RE: Submittal of Correction Pages
Dewatering/Barrier Wall Alignment Investigation Report
ACS NPL Site RD/RA
Griffith, Indiana

TECHNICAL MEMORANDUM
UPPER AQUIFER INVESTIGATION
MONITORING WELL AND SAMPLING
PROPOSAL
(REVISED MAY 3, 1996)

Re: Upper Aquifer Investigation Technical Memorandum
Response to Disapproval and Comments

FIGURE 1

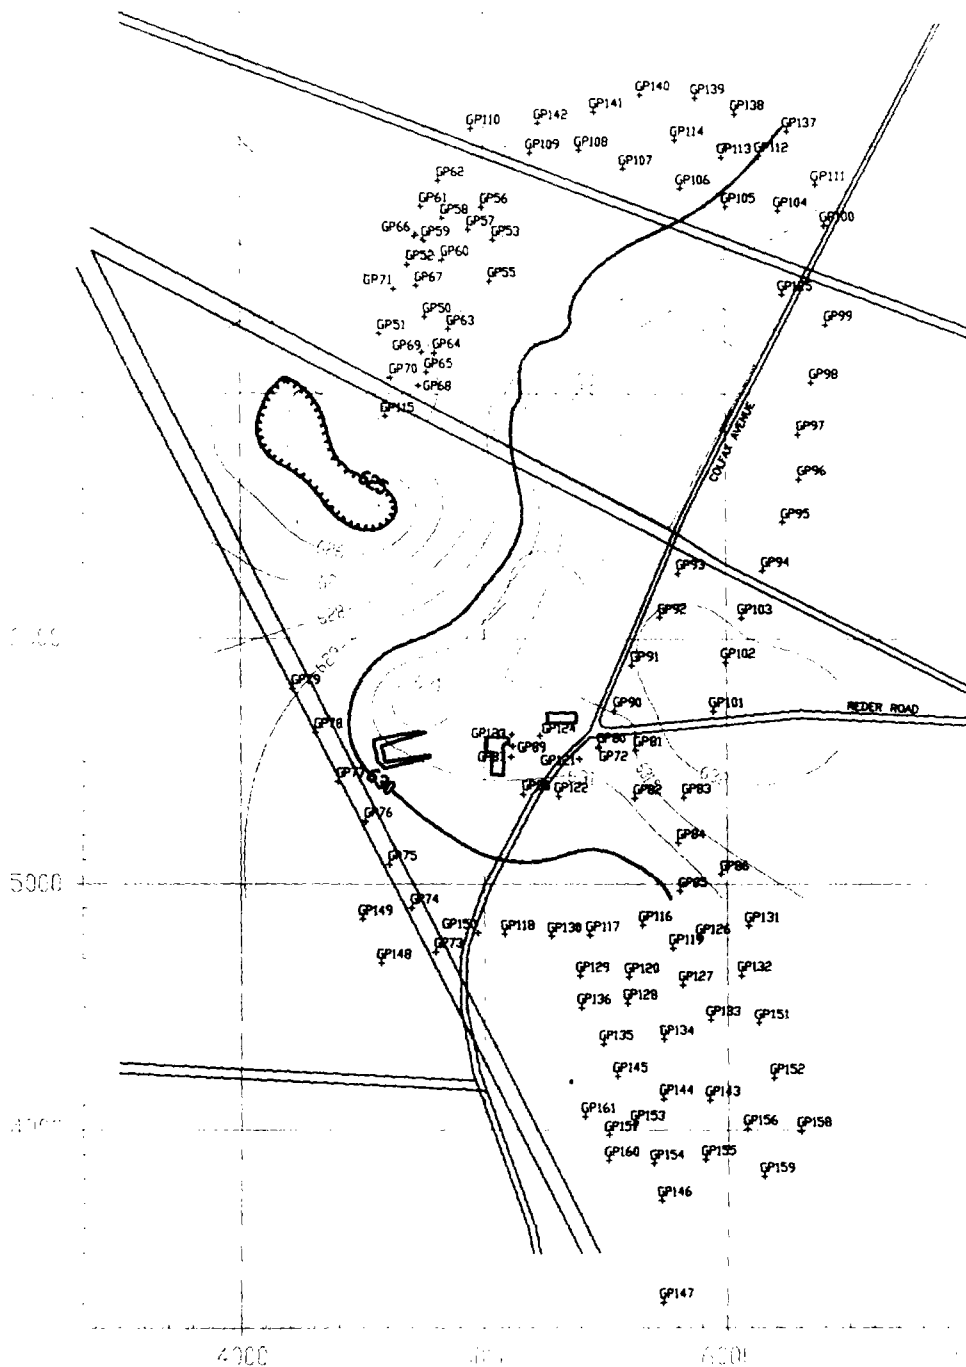
10. **Page 1, 2nd paragraph.** The boundaries of bulleted areas A,B,C and D described in this paragraph are not clear. Present the boundaries of these areas on Figure 1.

11. **Page 2, 3rd paragraph.** Present the location of MW-9 on Figure 1.

30. Table 1. Include all wells on Figure 1. For instance, MW 10C is not shown and should be included.

Areas A, B,C, and D were selected in the SOW to represent general areas that should be investigated with specific procedures. The areas are general and so the representation in Figure 1 is general. The letters A, B, C, and D are clearly marked and discussed in the text. No modifications to Figure 1 are necessary.

Figure 1 includes the upper aquifer monitoring wells and piezometers. Monitoring Well MW-9 is screened in the lower aquifer. Therefore it, along with the other lower aquifer wells, was not included on Figure 1.

The subject of this Technical Memorandum is the upper aquifer. Monitoring Well MW-10C is not an upper aquifer monitoring well, therefore, it is not included on Figure 1.

FIGURE 2

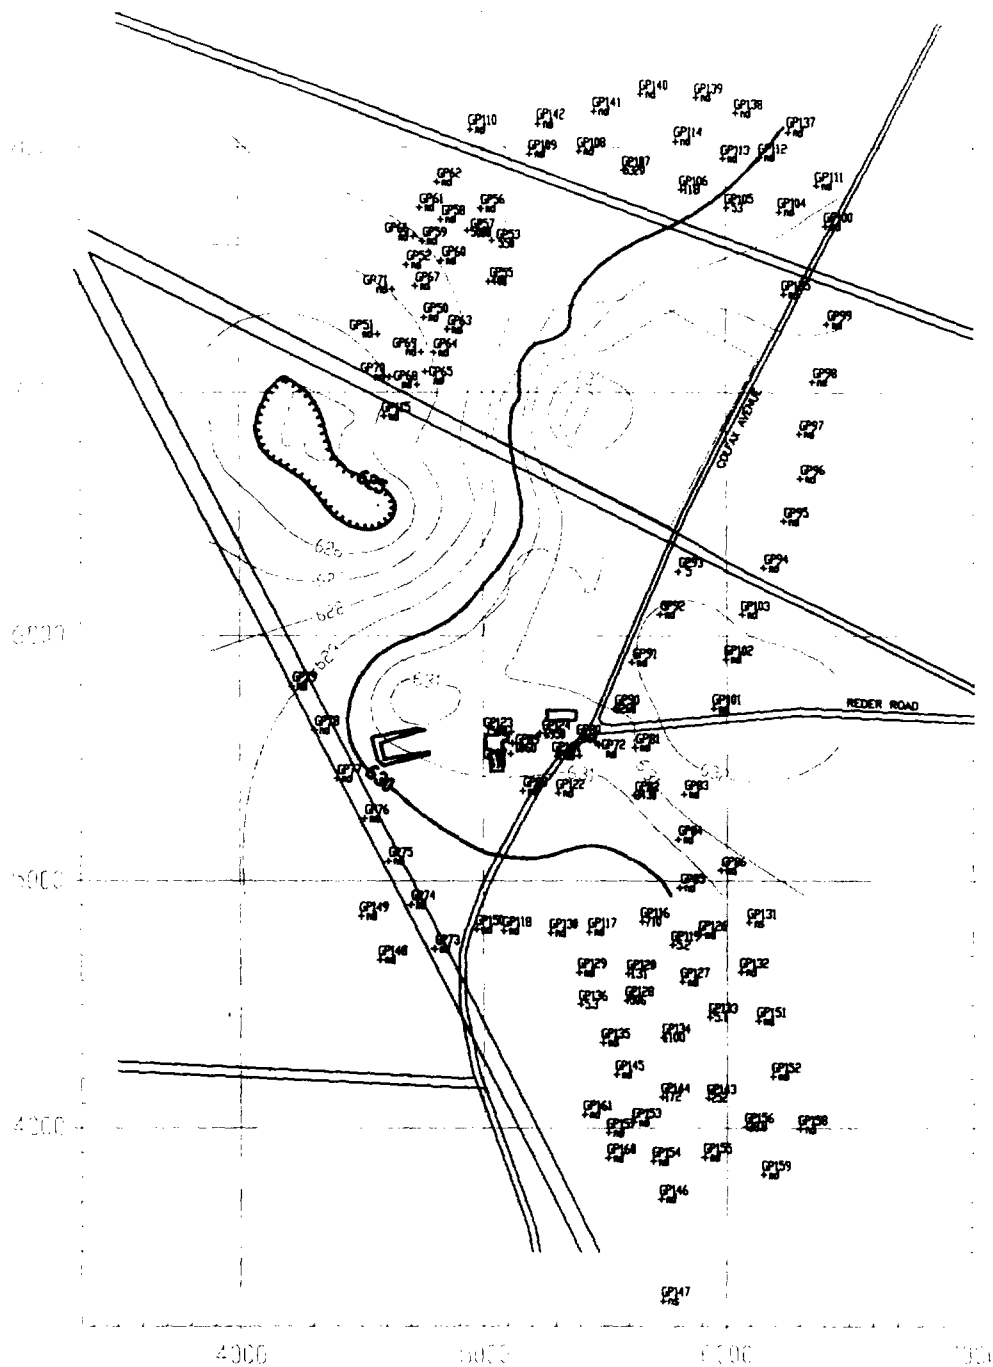
28. Page 11, last paragraph. This states that "One surface water sample was collected near P-61 north of the ACS facility (Figure 2)." The report previously states that the sample collected near piezometer P-63, and Figure 2 does not illustrate the location of the surface water sample. This needs to be corrected.

29. Page 11, Surface Water Samples. The surface water sample location was not plotted on the map. The surface water sample appears to have been collected near P-63, rather than P-61. Include the sampling location and ditch on figure 2.

The text of has been corrected in the revised Technical Memorandum.

FIGURE 5

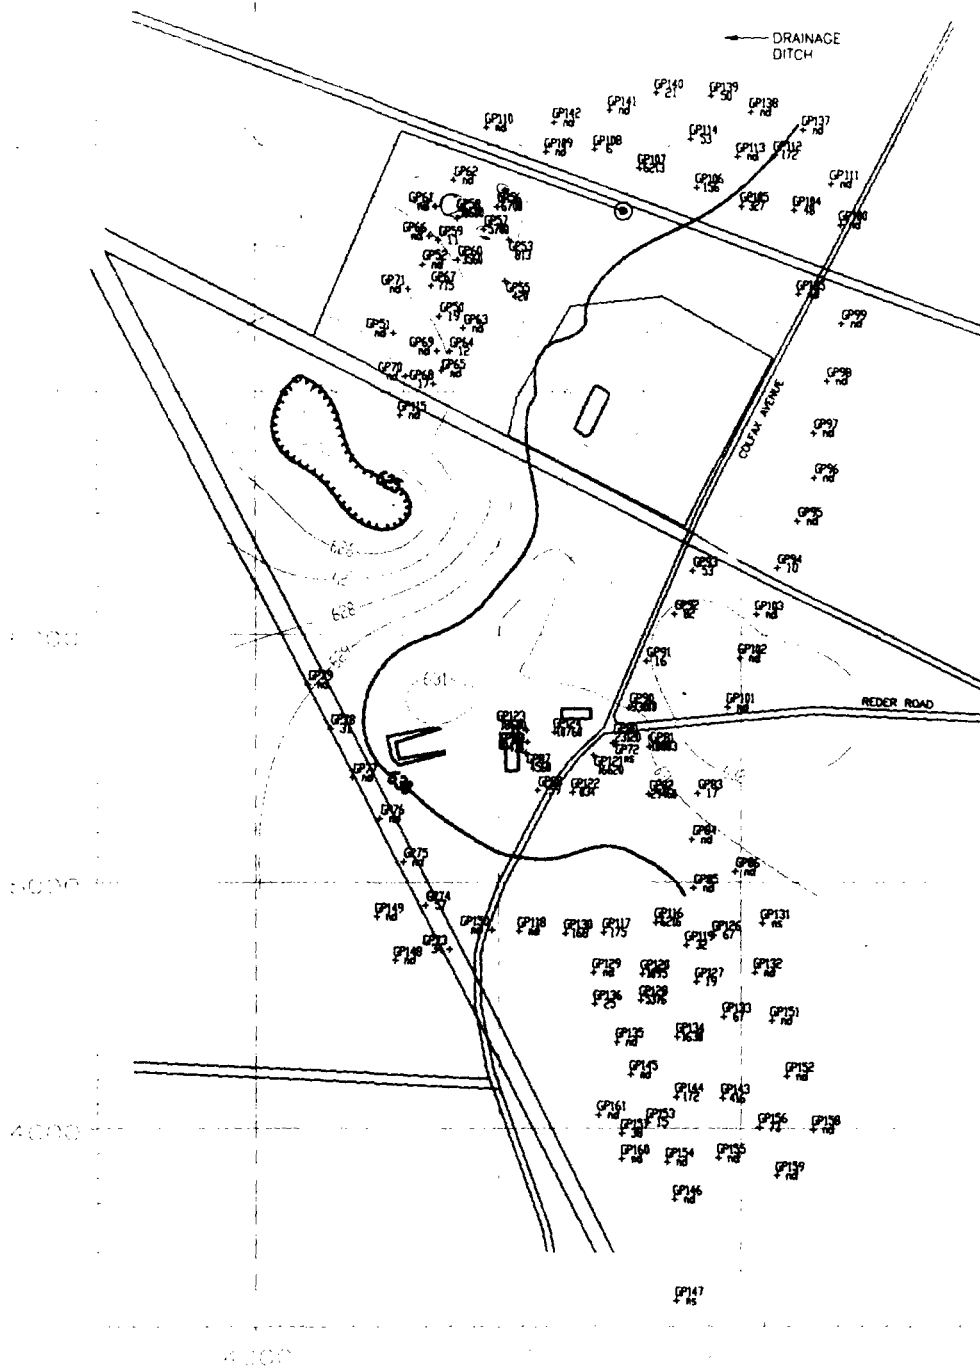
Most of what the U.S. EPA is requesting here was already included in the Upper Aquifer Technical Memorandum. The five figures in the first submittal of the Upper Aquifer Technical Memorandum contained the water table contours from the October 30, 1995 water level measurements. Figure 1 showed the existing upper aquifer wells and piezometers. Figure 5 showed the groundwater contamination plume as established by the upper aquifer field screening, and also showed the proposed monitoring well locations. All figures were purposefully provided at the same scale so that comparisons between any and all maps can be easily made.

A new figure has been added following Figure 4, and Figure 5 has been modified and renumbered as Figure 6 in the re-submitted Technical Memorandum. The new Figure 5 is a plot of total volatile organic concentration levels detected by field GC. Figure 6 (revised Figure 5) includes water table contour lines, the "zero" contaminant detection line, the existing monitoring wells and piezometers, and the locations of the new monitoring wells and piezometers proposed to complete the upper aquifer investigation.

FIGURE 6

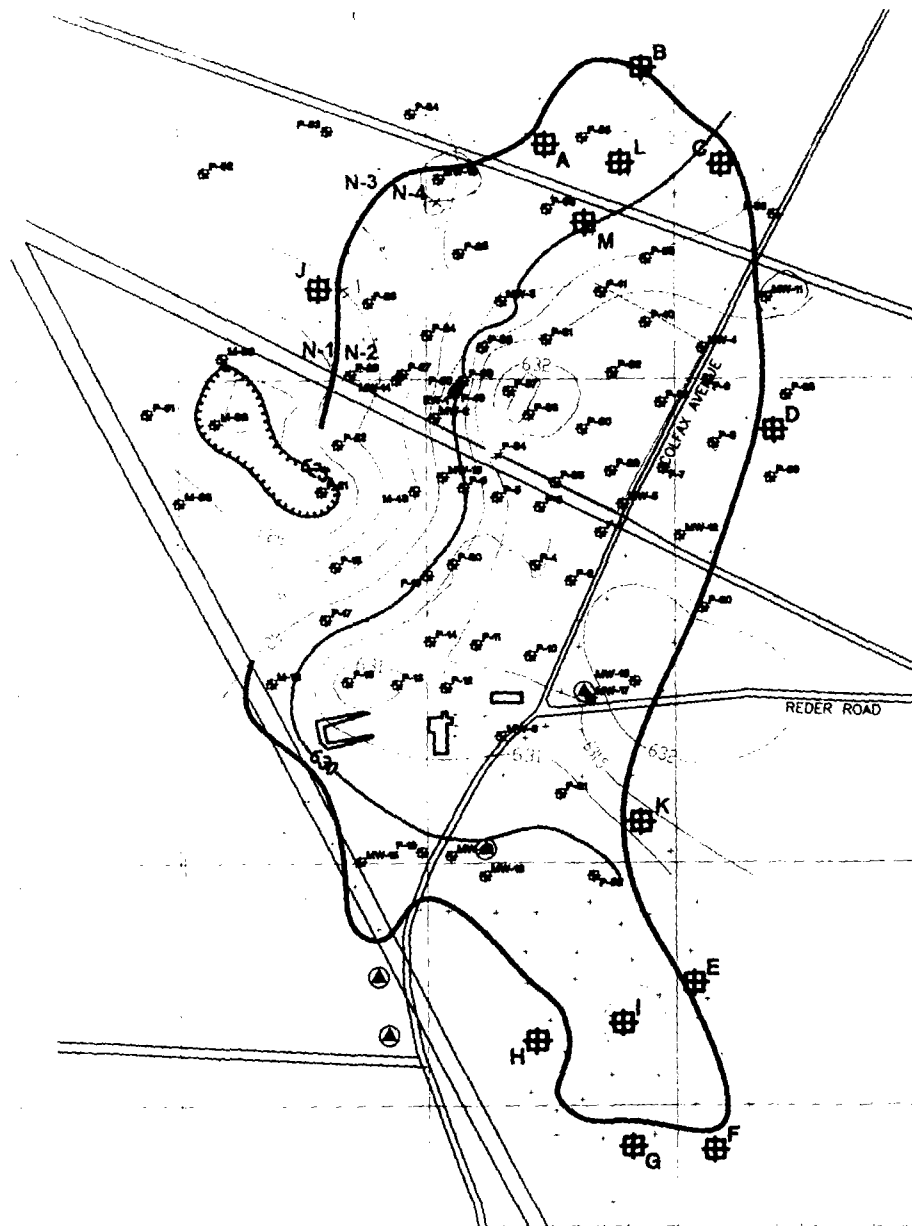
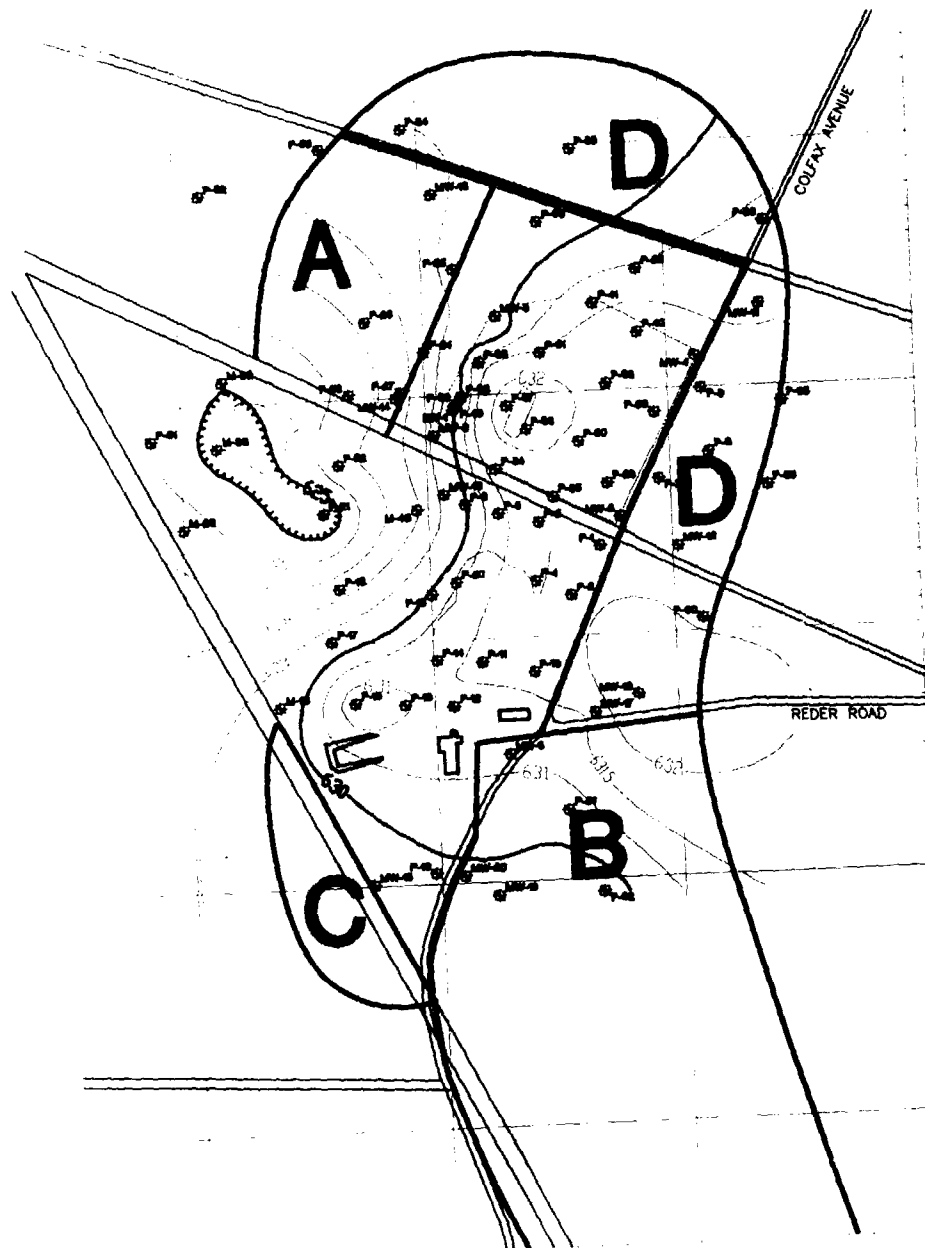
26. Page 10. Based upon the information provided, following are U.S. EPA opinions and recommendations of the proposed monitoring network. Although final well locations will be verified by U.S. EPA and IDEM in the field, Respondents should provide a proposal which considers the following.

Surface water sampling should be planned. Nested piezometers should be installed to verify gradients and allow for periodic chemical water quality samples to be obtained. Piezometers will be relatively easy to install and maintain. Locations should be on either side of the hypothesized chemical boundary and there should be a total of 6, two-piezometer nests installed. Given the historic conditions noted in MW 10 and vicinity, wells will likely be needed to show chemical changes through time and

Two wells are recommended (a cluster at each location) along the inferred plume axis, in addition to the well locations already shown. One monitoring well is suggested approximately 150 feet northeast of P-62, to provide adequate monitoring coverage of this area. An additional monitoring well is suggested approximately 500 feet south of P-62, to better define the nature of contamination within this area.

ii) Several shallow well clusters are anticipated along Colfax Avenue. A monitoring well is suggested between P-58 and P-59 just outside the line where benzene was detected, as specified on figure 5. This well will provide coverage of the area between MW-11 and MW-12, which are over 1000 feet apart. A monitoring well is suggested near P-63 to better define the nature of contamination in this area.

However, as directed by the U.S. EPA in the April 29, 1996 clarification letter, the text of the Technical Memorandum has been modified to include piezometers in sets of two, at four locations. These are shown on Figure 6 as N-1, N-2, N3, and N-4.

However, at the insistence of U.S. EPA, a well is proposed for installation at this location. It is labeled "J" on Figure 6 of the revised Technical Memorandum.

At the meeting with U.S. EPA and IDEM on April 23, 1996, the ACS Technical committee agreed to install an additional well interior to the plume extending southeast from the site. It is discussed on page 10 of the revised Technical Memorandum and it is labeled "T" on Figure 6

An additional upper aquifer monitoring well in the northern area of the plume was agreed to at the April 23, 1996 with U.S. EPA and IDEM. It is indicated by the symbol and letter "C" on Figure 6 of the revised Technical Memorandum.

At the insistence of U.S. EPA, two additional wells have been added to the upper aquifer investigation inside the contaminant plume zone north of the ACS facility. These are indicated by the symbols and letters "L" and "M" on Figure 6 in the revised Upper Aquifer Technical Memorandum.

During the discussion with U.S. EPA and IDEM on April 23, 1996, the ACS Technical Committee agreed to place an additional upper aquifer monitoring well at the location discussed above. It is indicated by the symbol and letter "D" on Figure 6 in the revised Upper Aquifer Technical Memorandum.

ENCLOSURE B

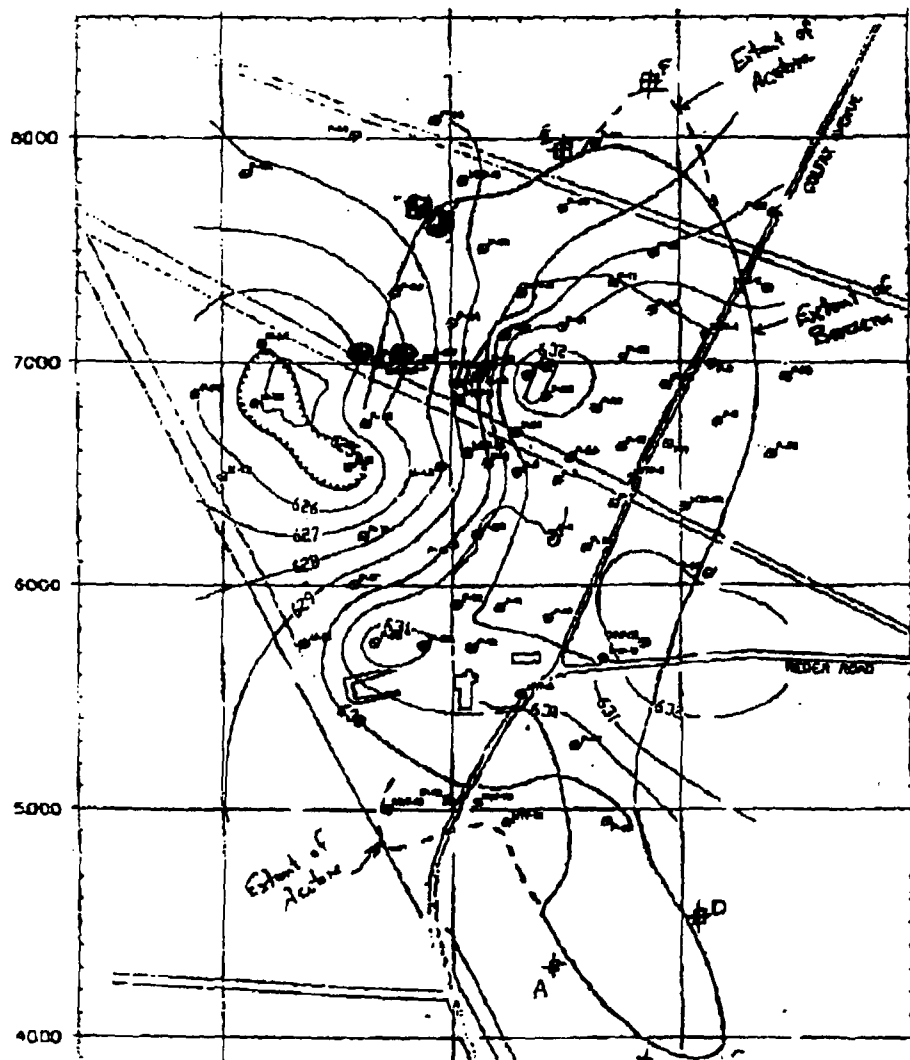
Approximate
proposed piezometer
locations

(2 piezometers per
location)
